# AGENDA

## ARCHITECTURAL REVIEW BOARD MEETING

MARCH 12, 2024 IN THE CITY COUNCIL CONFERENCE ROOM AT 5:00 PM

**TO:** Planning and Zoning Commission  
**DATE:** March 12, 2024  
**APPLICANT:** Dub Douphrate; *Douphrate & Associates, Inc.*  
**CASE NUMBER:** SP2024-003; *Site Plan for a Two (2) Metal Buildings at 196 & 216 Ranch Trail*

**EAST ELEVATION (FACING ALPHA RD)**  
 (98% STONE) REVISED PER ARB TO 19% STONE 79% BRICK 2% WOOD SIDING  
 SURFACE AREA 1,319 SF

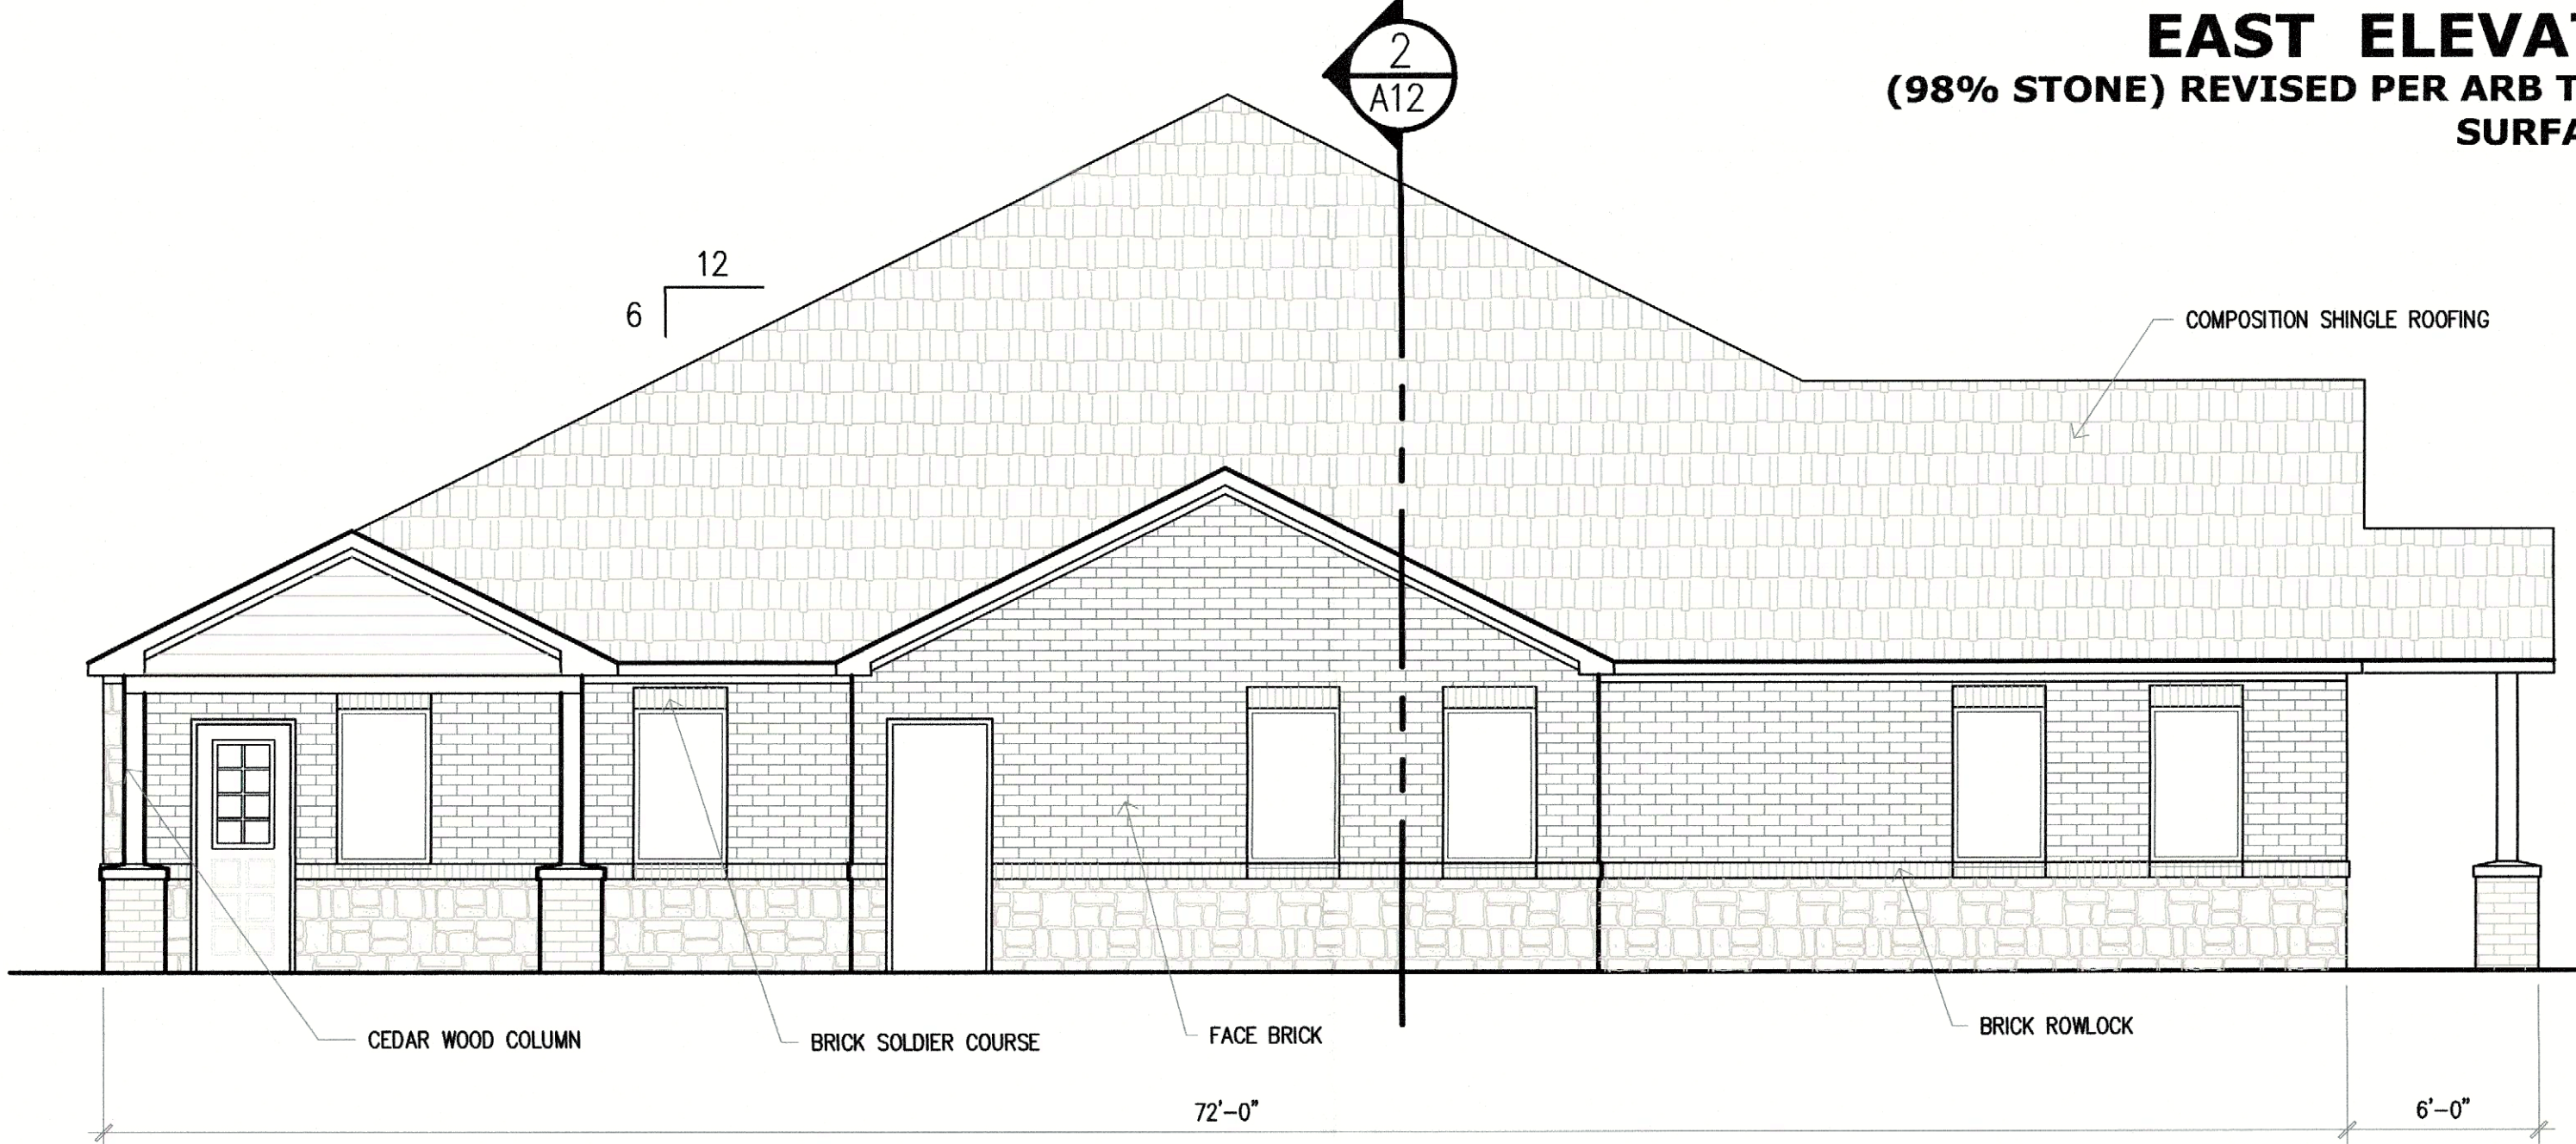
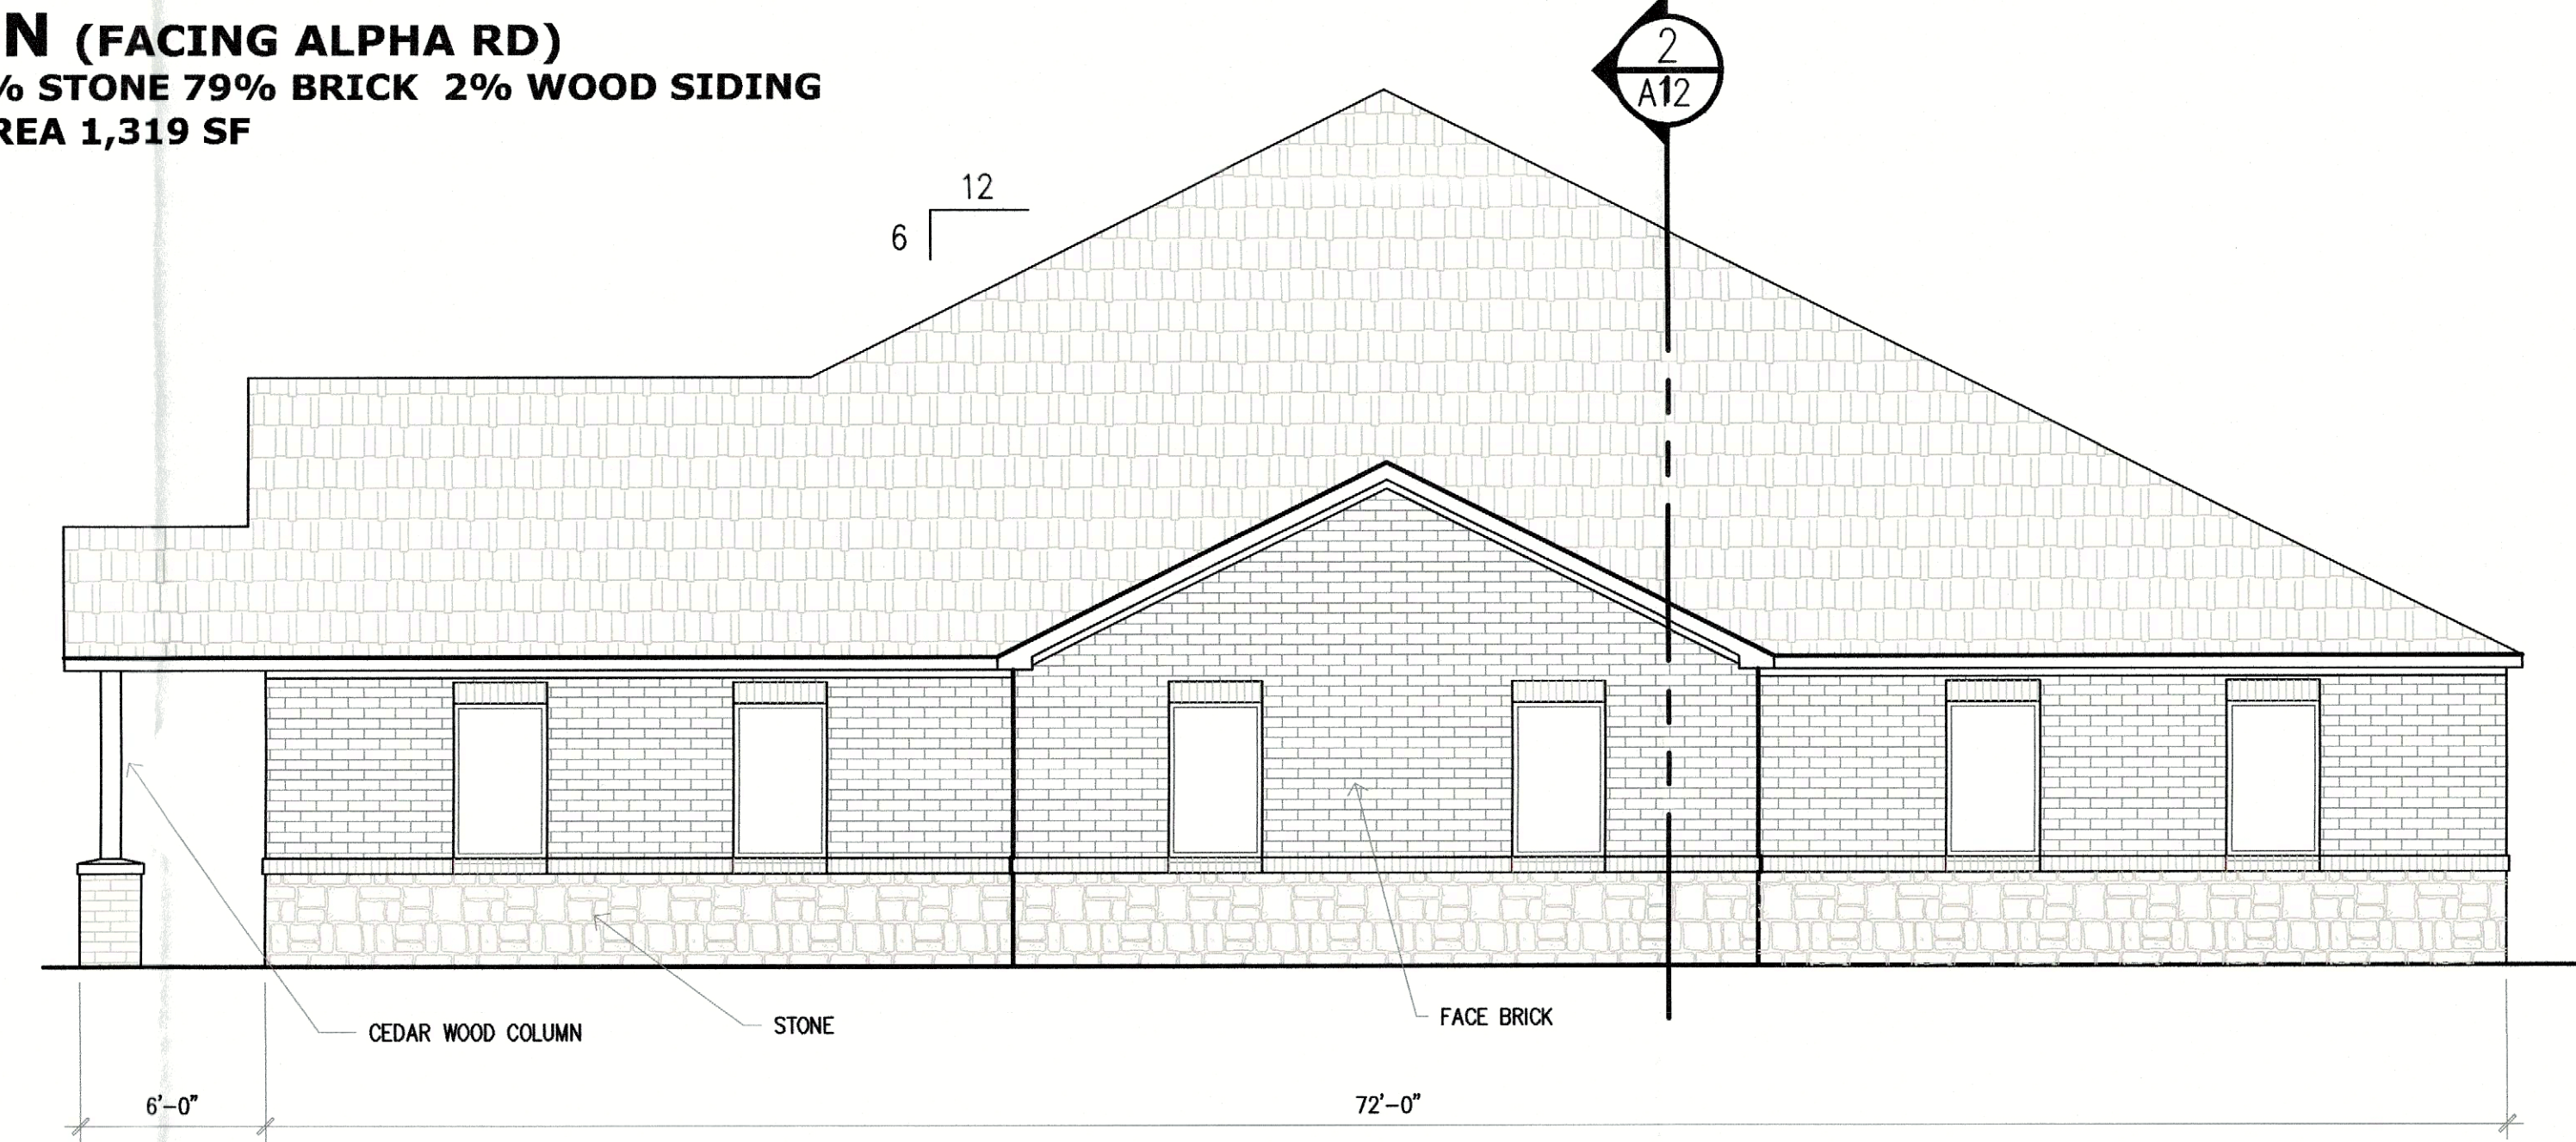
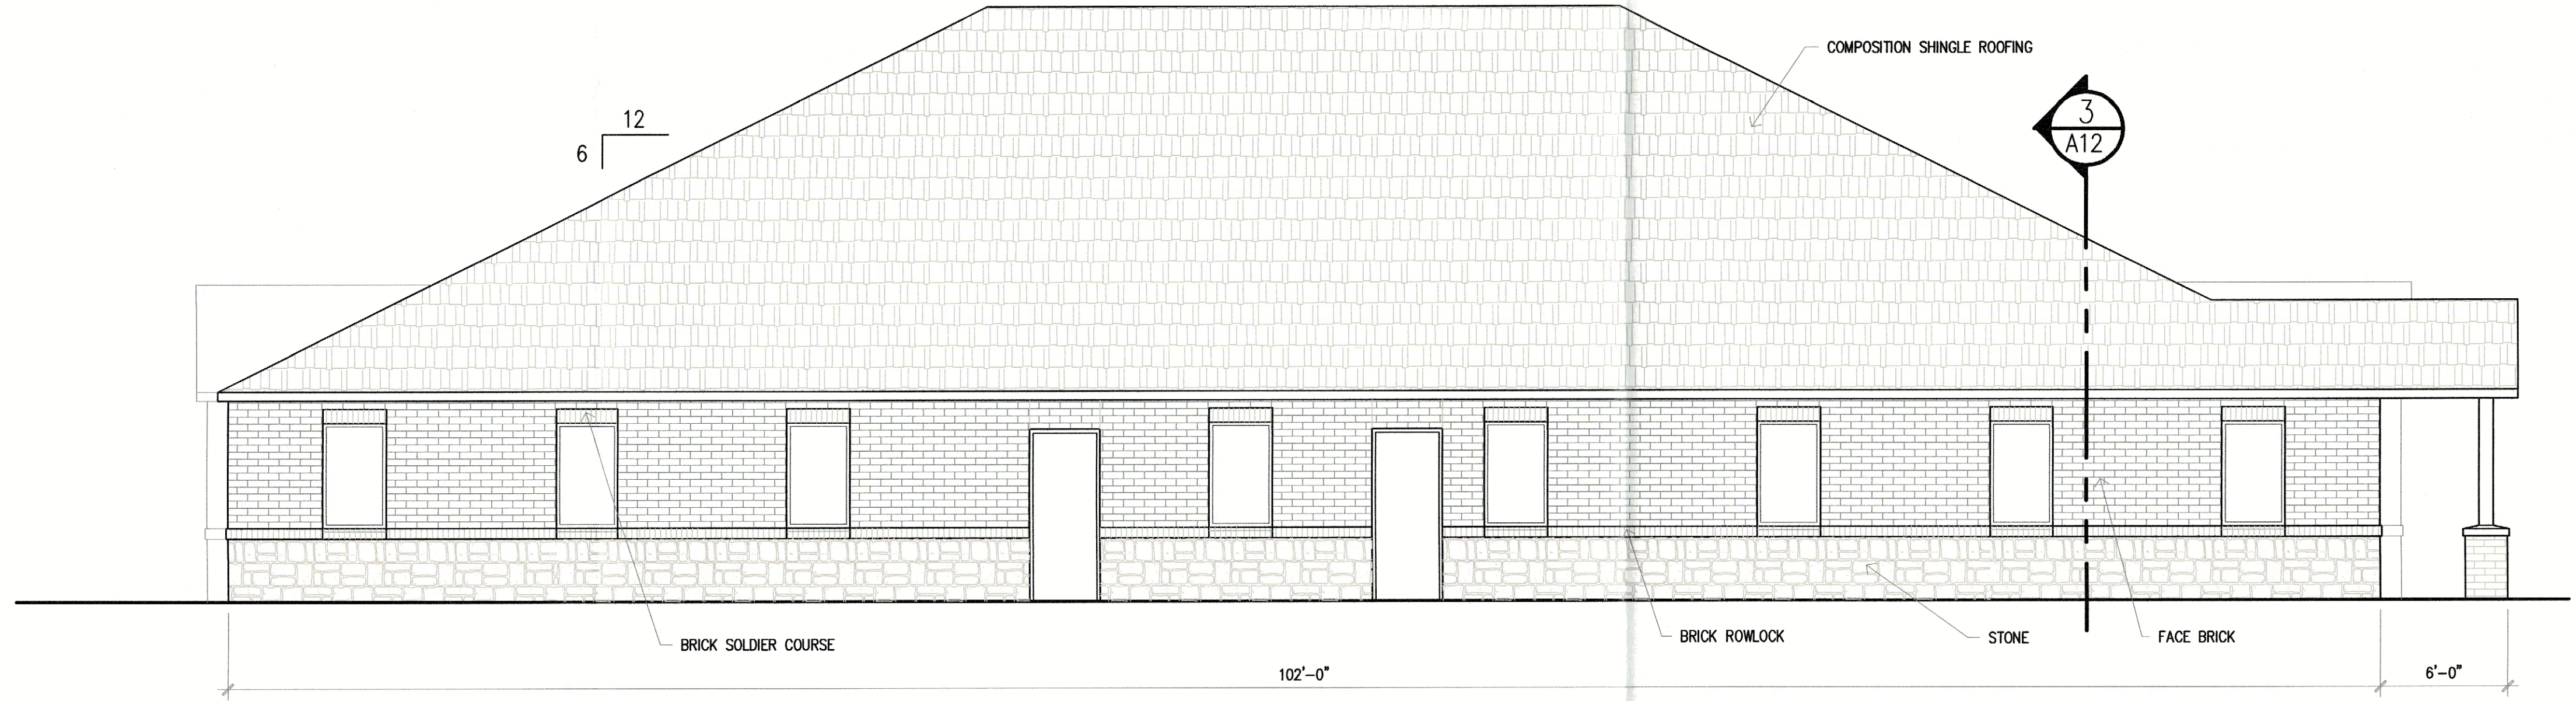
- (2) Primary Articulation. According to Article 05, *General Industrial District Standards*, of the Unified Development Code (UDC), "A primary building façade is any building façade that has a primary entryway for a business or that has an adjacency to a public right-of-way, open space/green space, public/private park, and/or a residential zoning district or residentially used property. All industrial buildings shall meet the standards for articulation on primary building façades as depicted in Figure 8." In this case, the building elevations do not meet the standards for articulation on all the facades, specifically the projection and wall length requirements. This will require the approval of an Exception from the Planning and Zoning Commission.
